SUBJECT: TECHNICAL SPECIFICATION CHANGES TO SUPPORT CYCLE 4 OPERATION
(TAC NO. 73588)

RE: SUSQUEHANNA STEAM ELECTRIC STATION, UNIT 2

Amendment No. 58
License No. NPF-22

ATTACHMENT TO LICENSE AMENDMENT NO. 58

**MAXIMUM AVERAGE PLANAR LINEAR HEAT
GENERATION RATE (MAPLHGR) VERSUS
AVERAGE BUNDLE EXPOSURE
ANF 9X9 FUEL
FIGURE 3.2.1-1**

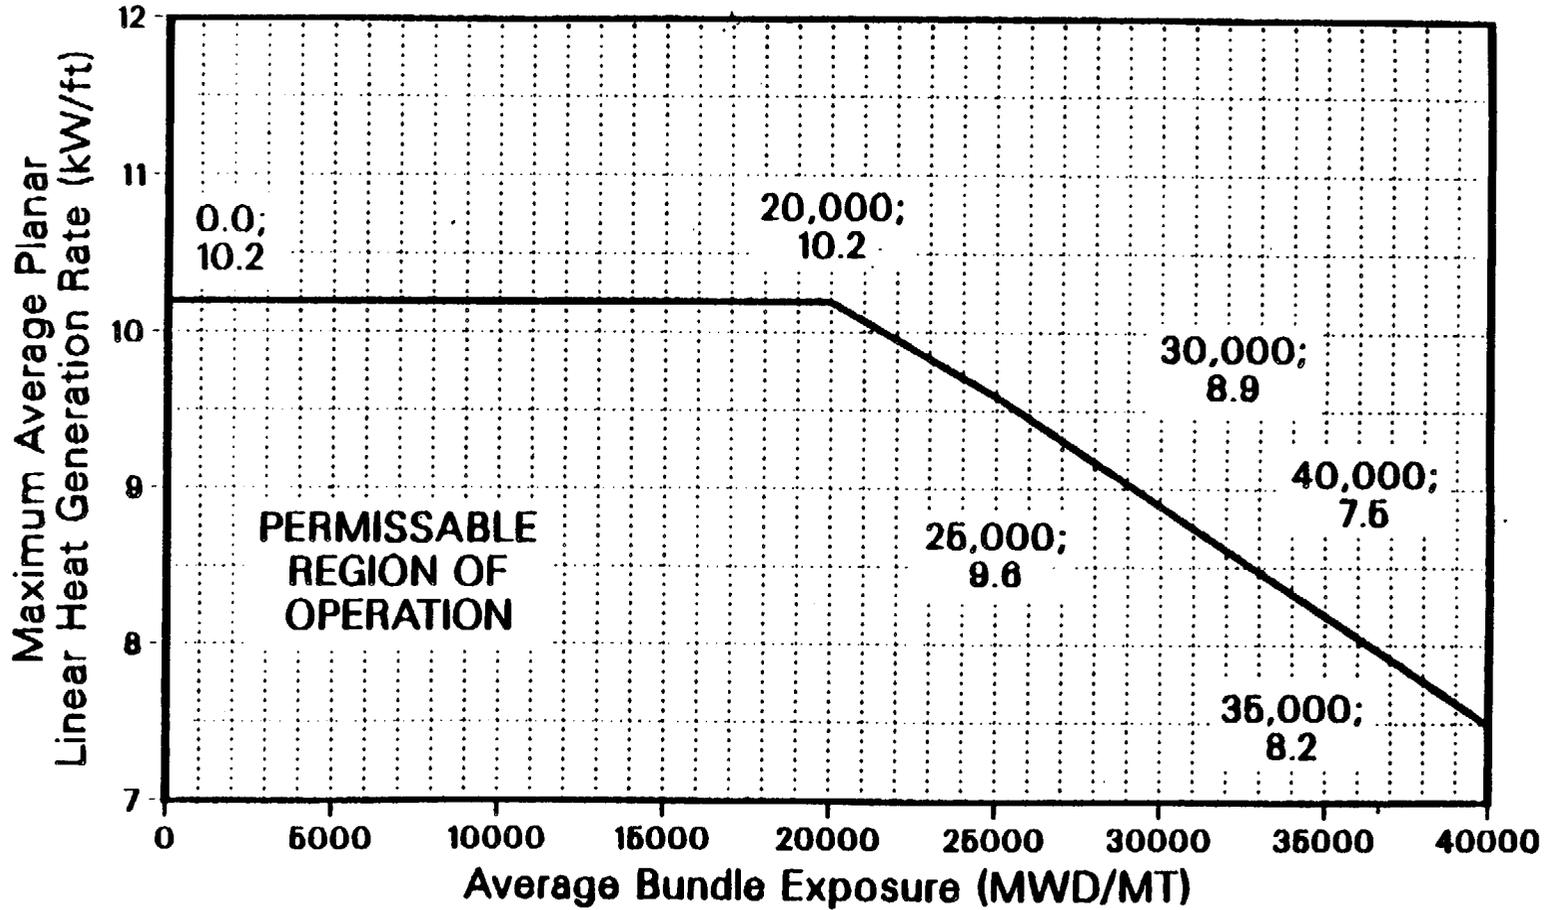
3.2.1 All AVERAGE PLANAR LINEAR HEAT GENERATION RATES (APLHGRs) for all fuel shall not exceed the limit shown in Figure 3.2.1-1.

The peak cladding temperature (PCT) following a postulated loss-of-coolant accident is primarily a function of the average heat generation rate of all the rods of a fuel assembly at any axial location and is dependent only secondarily on the rod to rod power distribution within an assembly. The Technical Specification APLHGR for ANF fuel is specified to assure the PCT following a postulated LOCA will not exceed the 2200°F limit. The limiting value for APLHGR is shown in Figure 3.2.1-1.

The calculational procedure used to establish the APLHGR shown on Figure 3.2.1-1 is based on a loss-of-coolant accident analysis. The analysis was performed using calculational models which are consistent with the requirements of Appendix K to 10 CFR 50. These models are described in XN-NF-80-19, Volumes 2, 2A, 2B and 2C.

LINEAR HEAT GENERATION RATE FOR APRM SETPOINTS
VERSUS AVERAGE PLANAR EXPOSURE
ANF FUEL
FIGURE 3.2.2-1

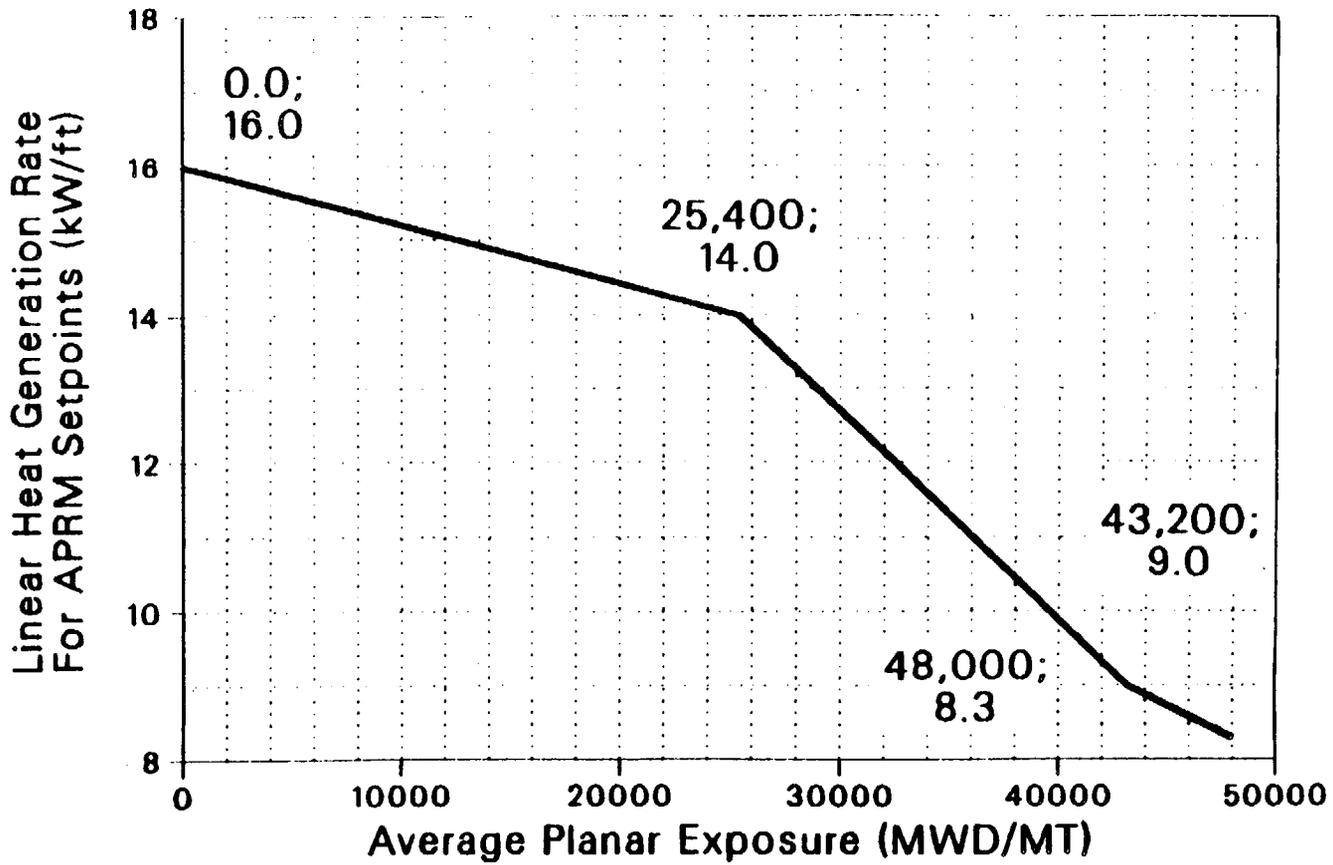
For ANF fuel the T factor used to adjust the APRM setpoints is based on the FLPD calculated by dividing the actual LHGR by the LHGR obtained from Figure 3.2.2-1. The LHGR versus exposure curve in Figure 3.2.2-1 is based on ANF's Protection Against Fuel Failure (PAFF) line shown in Figure 3.4 of XN-NF-85-67(A), Revision 1. Figure 3.2.2-1 corresponds to the ratio of PAFF/1.2 under which cladding and fuel integrity is protected during A00's.

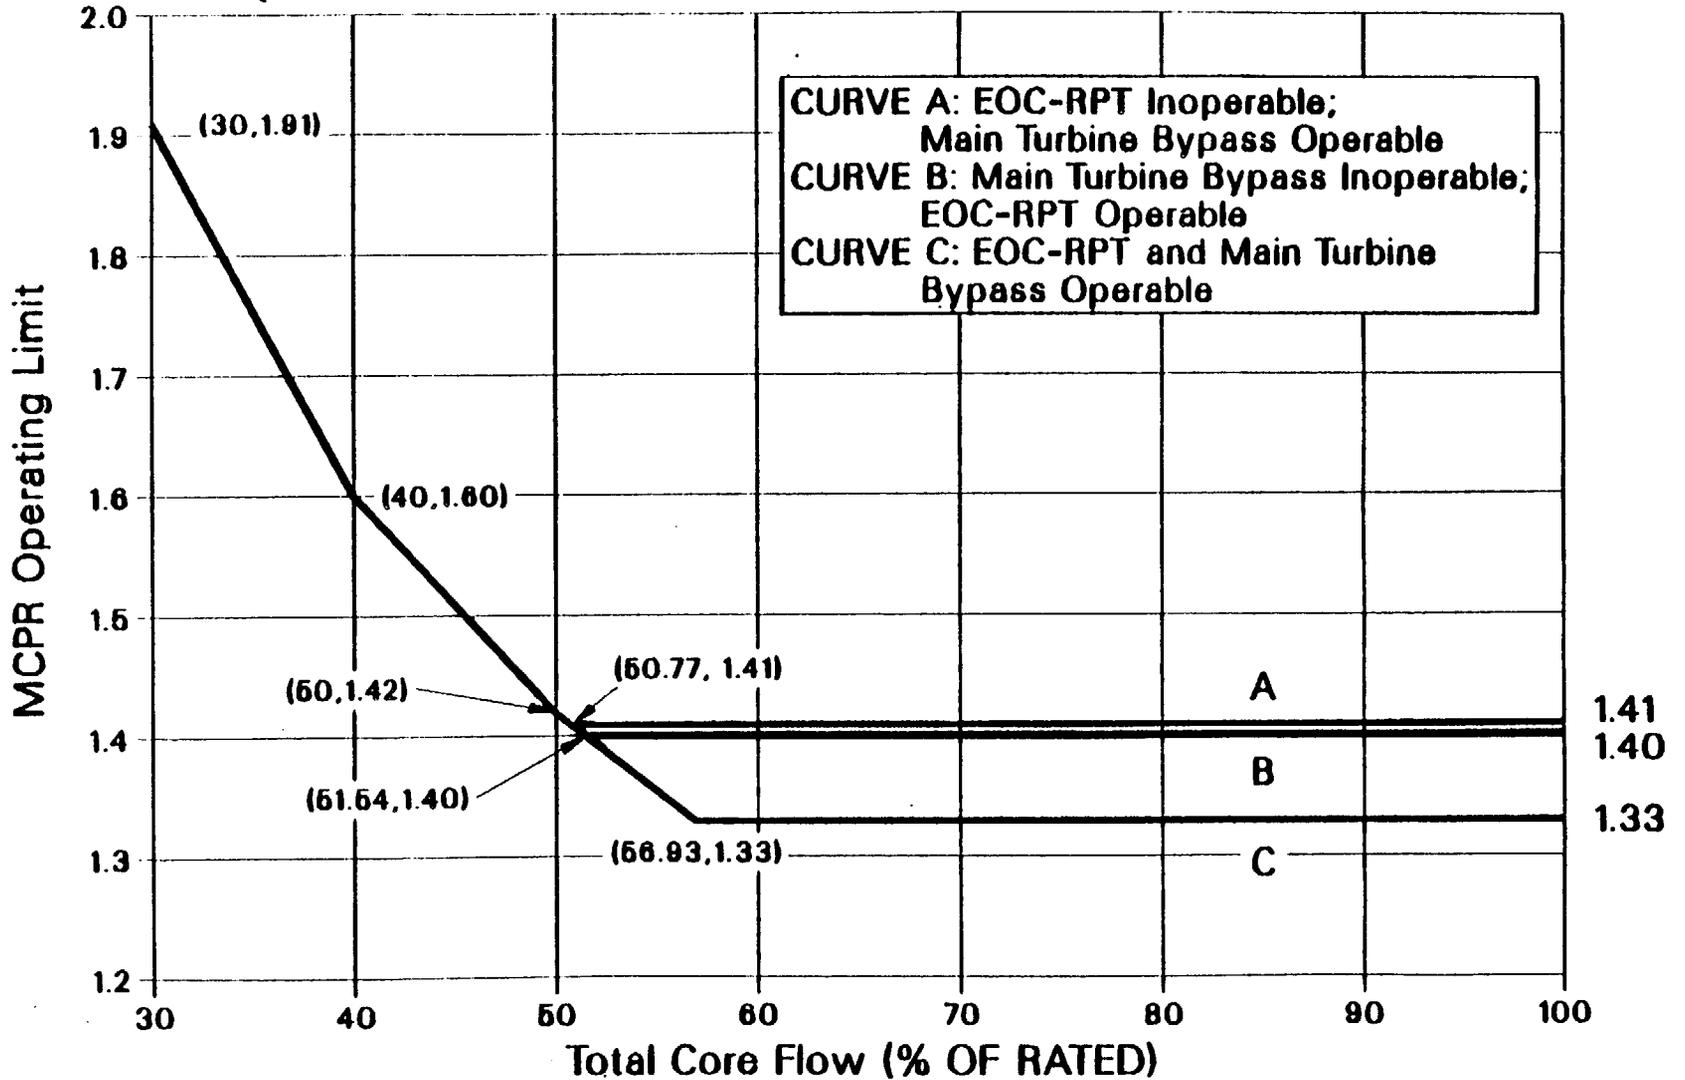
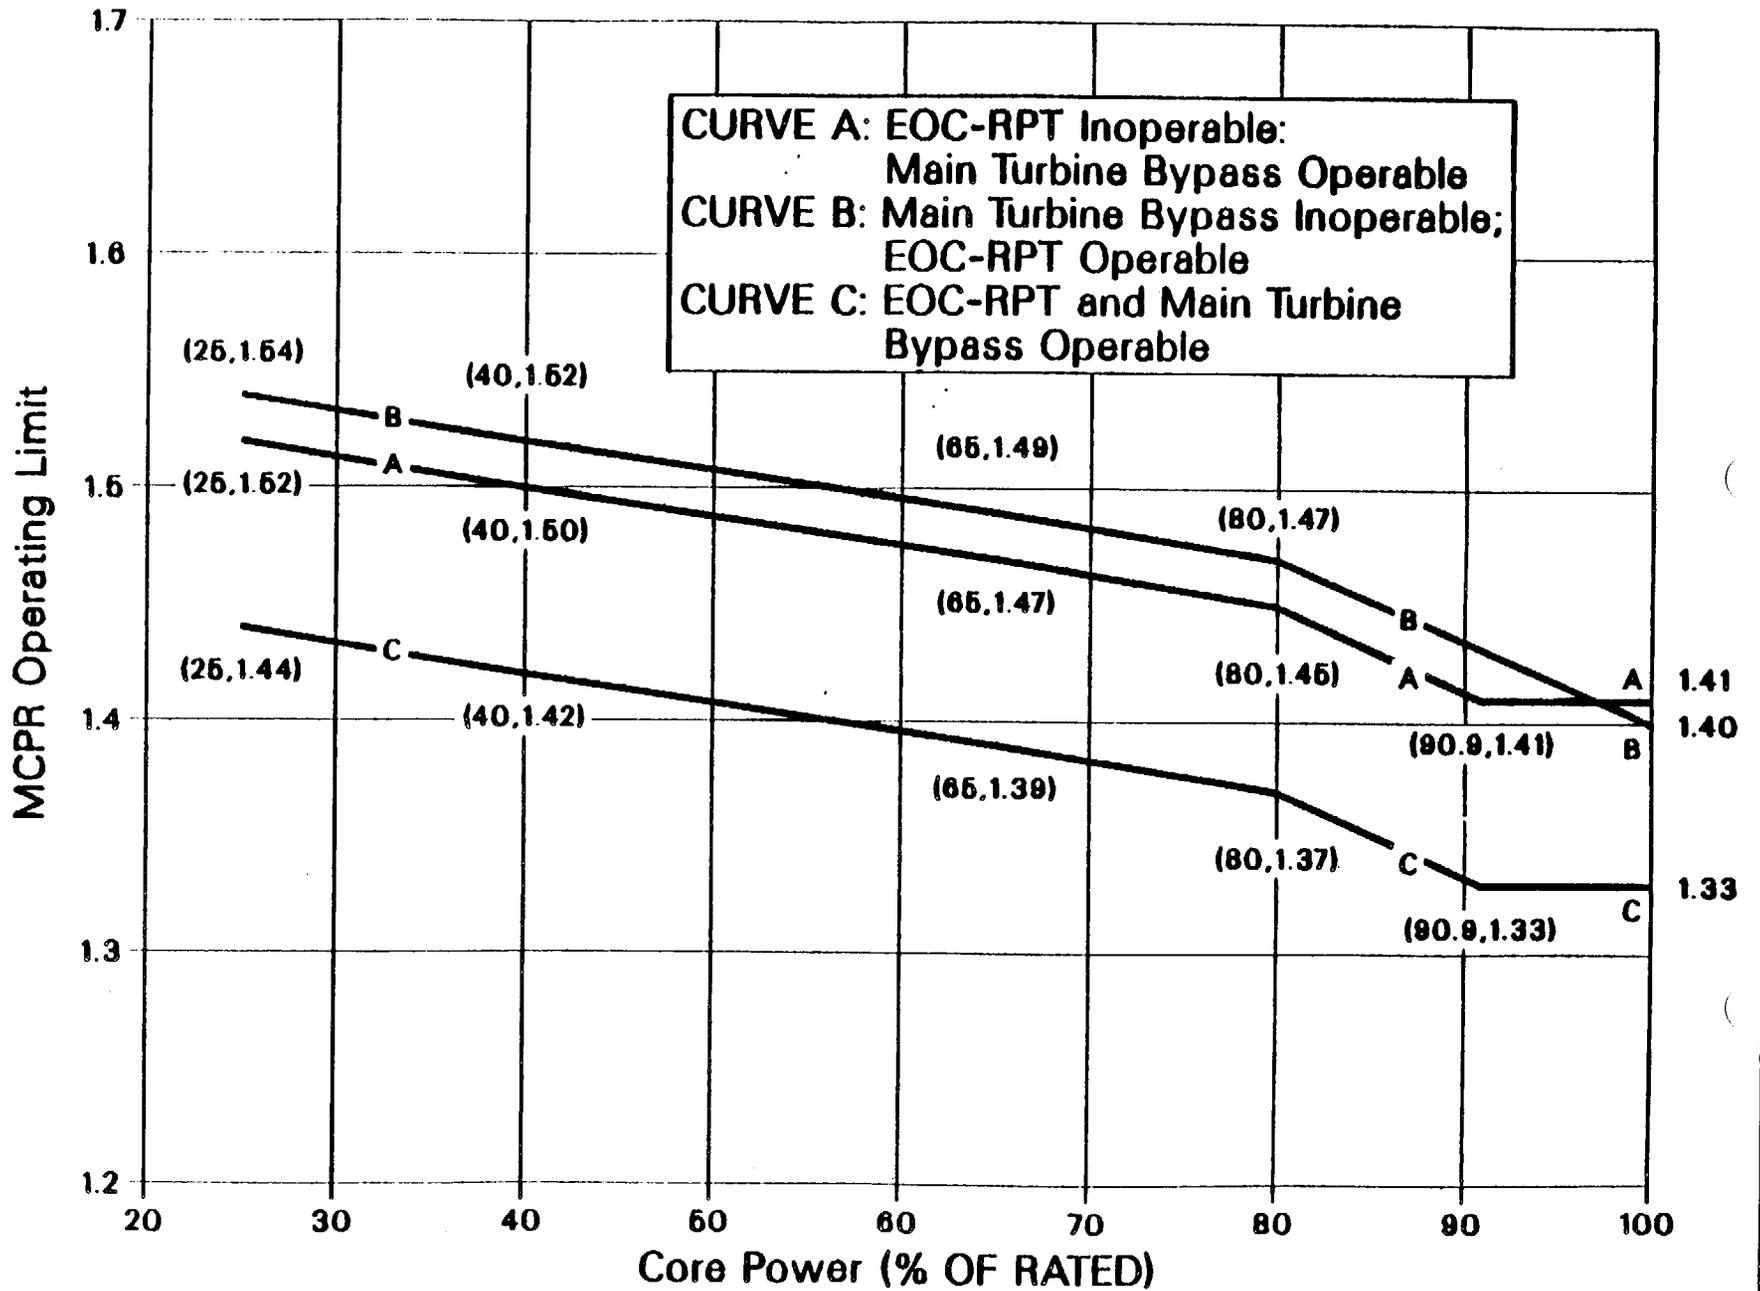
3.2.3 The MINIMUM CRITICAL POWER RATIO (MCPR) shall be greater than or equal to the greater of the two values determined from Figure 3.2.3-1 and Figure 3.2.3-2.

Figure 3.2.3-1 defines core flow dependent MCPR operating limits which assure that the Safety Limit MCPR will not be violated during a flow increase transient resulting from a motor-generator speed control failure. The flow dependent MCPR is only calculated for the manual flow control mode. Therefore, automatic flow control operation is not permitted. Figure 3.2.3-2 defines the power dependent MCPR operating limit which assures that the Safety limit MCPR will not be violated in the event of a Feedwater Controller Failure, Rod Withdrawal Error, or Load Reject Without Main Turbine Bypass operable initiated from a reduced power condition.

Operating limit MCPRs displayed in Figures 3.2.3-1 and -2 have been revised to reflect the results of the cycle specific transient analyses. The methodology used to evaluate the limiting transients and accidents is consistent with

previously approved methods and meets all the appropriate criteria. Therefore, the revised MCPRs are acceptable for S2C4 as discussed in this SER.

**LINEAR HEAT GENERATION RATE (LHGR) LIMIT
VERSUS AVERAGE PLANAR EXPOSURE
ANF 9X9 FUEL
FIGURE 3.2.4-1**

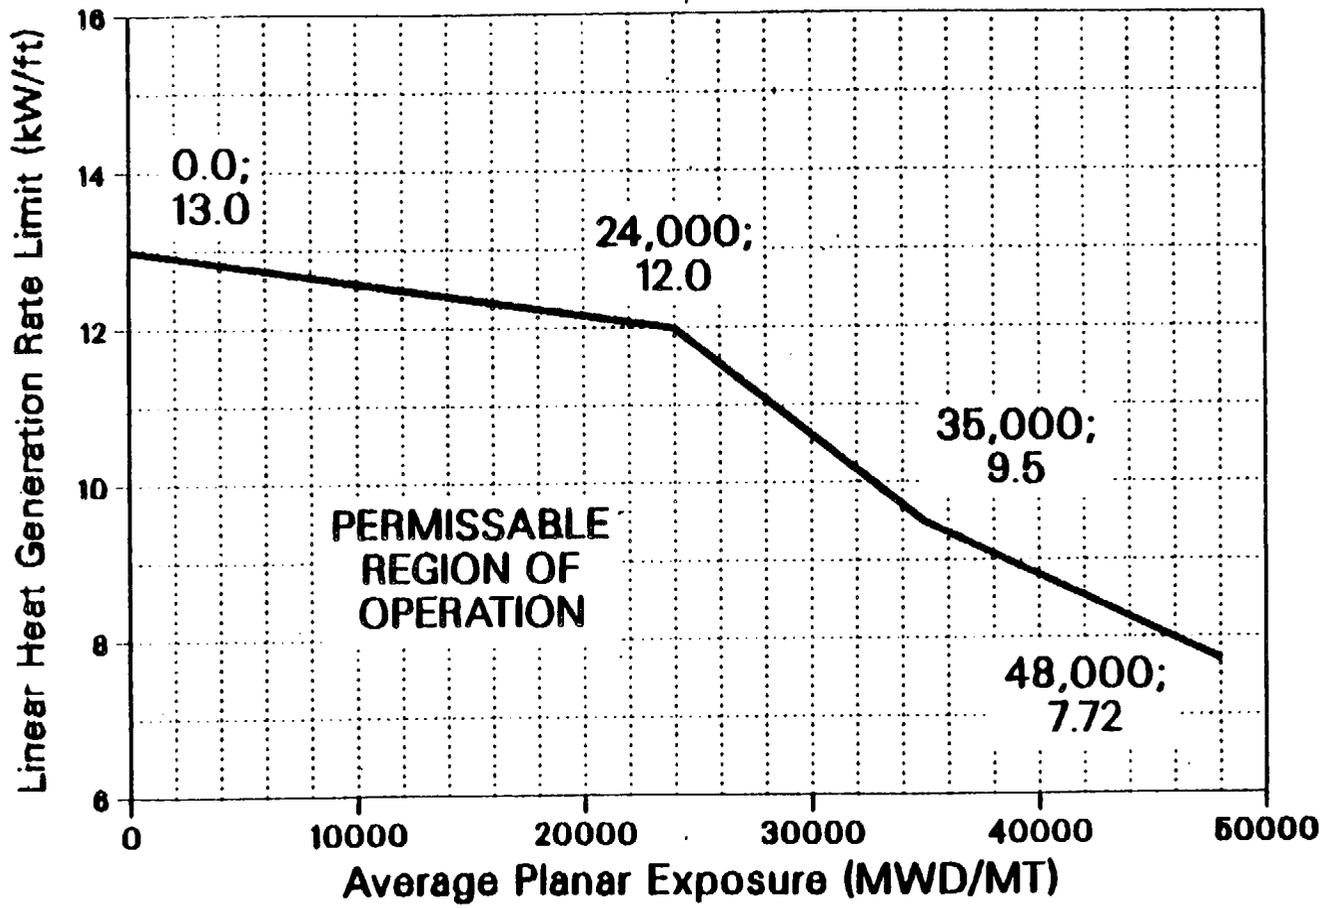
3.2.4 The LINEAR HEAT GENERATION RATE (LHGR) shall not exceed the LHGR limit determined from Figure 3.2.4-1.

A figure of LHGR limit versus planar exposure (MWd/MTU) for the ANF 9x9 fuel is incorporated into the SSFS, Unit 2 Technical Specifications (Figure 3.2.4-2 attached to Reference 1). This Figure was approved in Reference 6 to reflect the design values which have been previously reviewed and approved for the ANF 9x9 fuel in connection with the staff's review of Reference 5. Based on the results of the generic review, the staff finds the LHGR limits for the 9x9 fuel to be acceptable.

Figure 3.4.1.1.1-1
THERMAL POWER/CORE FLOW LIMITATIONS

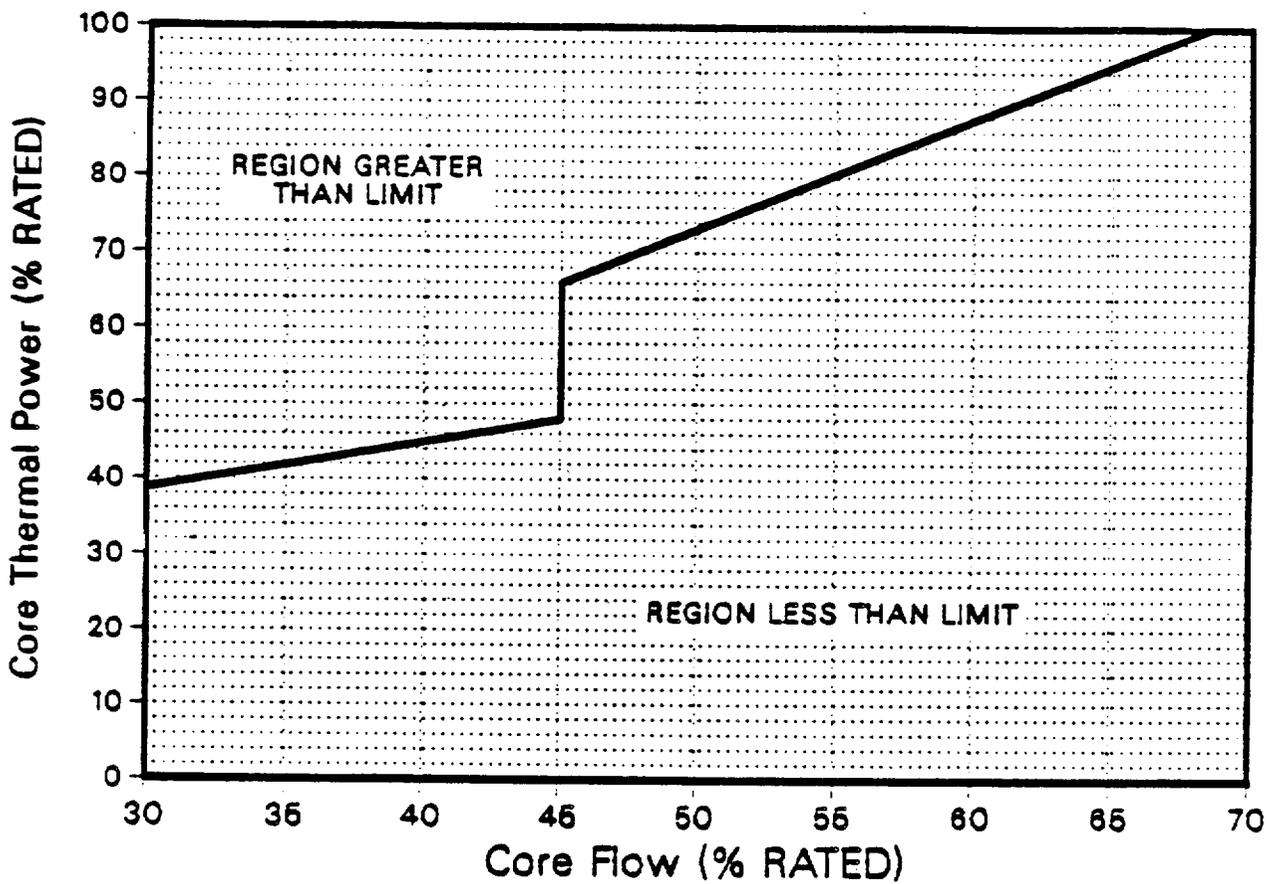
The references to 55 million lbs/hr core flow have been removed. Reference is now only to the curve in Figure 3.4.1.1.1-1 which provides the correct limit. The curve has been extended to cover operation up to full power. The 55 million lb/hr limit was only a quick, approximate reference for the operator. The change is editorial and is acceptable. This will be changed again by the THS TS review discussed in Section 2.3 of this review.

- (d) Figure 3.4.1.1.2-1 has been deleted and all references to that figure are changed to Figure 3.4.1.1.1-1. This change is acceptable, however, it is irrelevant since, as discussed in Section 2.3, new TS have been separately reviewed and approved for THS, and these TS will replace the specifications referring to this figure.
